PROJECT OVERVIEW

The proposed project is a five story mixed-use (multi-family residential and retail) project. The project will include amenities (fitness, lounges, roof deck, etc), two levels of below grade parking for commercial and residential use and approximately 7,000 sf of retail, 368 units and 444 parking stalls, with an additional 14 stalls of on-street parking along 130th Ave NE. Construction type is assumed as Type IIIA over Type IA. The project includes approximately 400,000 SF of development.

RESPONSES TO DESIGN GUIDELINES

REVIEW OF CDC

MASSING OPTION 3 (PREFERRED)

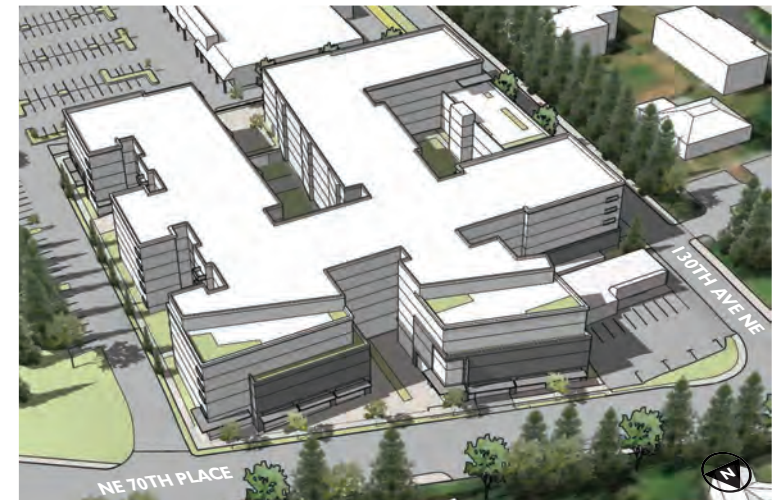
The board supported the locations of the through-block connections along the southern and eastern property lines.

The board appreciated the smaller public spaces along the eastern through-block connection for pausing along the slope. The board would like to see seating in these areas.

The Design Review Board supports preferred massing #3, shown here.
